Access Compliance Report

Public Rights-of-Way

(Curb Ramps)

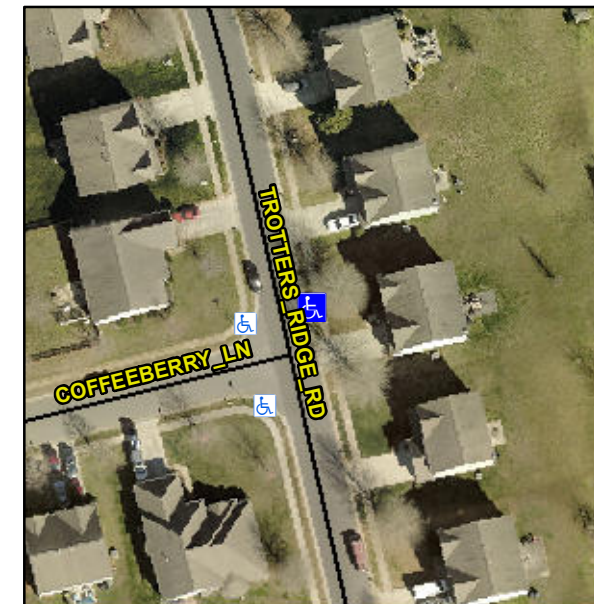
Not Found, R304.2.2

Compliance	Description	Data	Compliance	Description	Data
N/A	Ramp Length (in)	46.5	No	Ramp Slope (%)	10.7
Yes	Ramp Width (in)	48.0	Yes	Ramp XSlope (%)	1.9
N/A	Flare Type LT	N/A	N/A	Flare Type RT	N/A
N/A	Flare Slope LT (%)	N/A	N/A	Flare Slope RT (%)	N/A
N/A	Flare Traversable LT?	N/A	N/A	Flare Traversable RT?	N/A
N/A	Landing Length (in)	N/A	N/A	DWS Provided?	N/A
N/A	Landing Width (in)	N/A	N/A	DWS Contrast?	N/A
N/A	Landing Slope (%)	N/A	N/A	DWS Length (in)	N/A
N/A	Landing X Slope (%)	N/A	N/A	DWS Full Width?	N/A
N/A	Landing Curb? (Y/N)	N/A	N/A	DWS Offset (in)	N/A
N/A	Shared Landing?	N/A			
N/A	Gutter Ponding?	N/A	N/A	Gutter Slope (%)	N/A
N/A	Gutter Lip Ht (in)	N/A	N/A	Gutter X Slope (%)	N/A
N/A	Painted X Walk1?	No	N/A	Painted X Walk2?	N/A
	X Walk 1 Direction	To W		X Walk 2 Direction	N/A
N/A	X Walk 1 Width (in)	N/A	N/A	X Walk 2 Width (in)	N/A
	X Walk 1 Slope (%)	1.9		X Walk 2 Slope (%)	N/A
	X Walk 1 X Slope (%)	0.7		X Walk 2 X Slope (%)	N/A

Remove & Replace Entire Ramp.
